Access Compliance Report Public Rights-of-Way (Pedestrian Signals)

Main Street: VALENCIA_AVE Cross Street: VALENCIA_AVE Location: SW

ADA ID: SGAT220218174413 Signal Type: One Push Button-Non APS Overall Compliance: No Severity Scores: BTN 1: 35 BTN 2: N/A No BTN: N/A

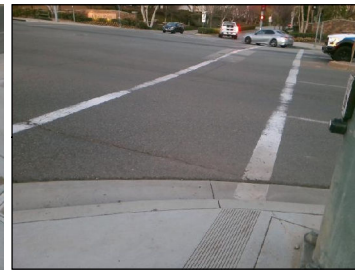
OC Std/PROW: R404.2, R403.4, MUTCD 4e.08

Possible Solutions: Replace Signal Push Button With APS Button. Remove and Replace Clear Space.
